2.3 Radiation Monitoring Systems

The information in this section of the ABWR DCD, including all subsections, tables, and figures, is incorporated by reference with the following departures.

STD DEP T1 2.3-1 (Figure 2.3.1)

Figure 2.3.1 Process Radiation Monitoring System Control Interface Diagram

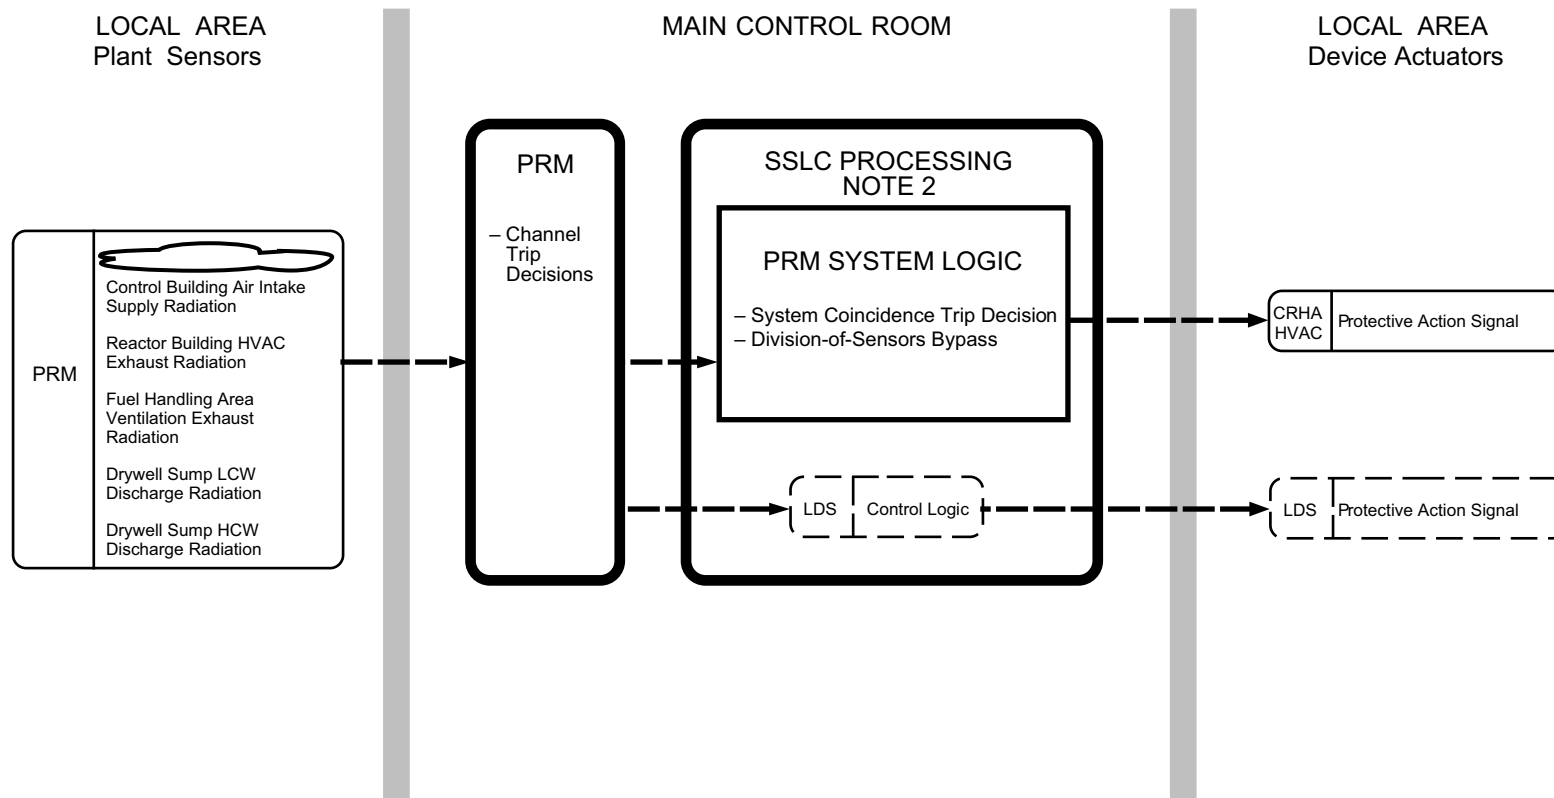
STD DEP T1 2.3-1
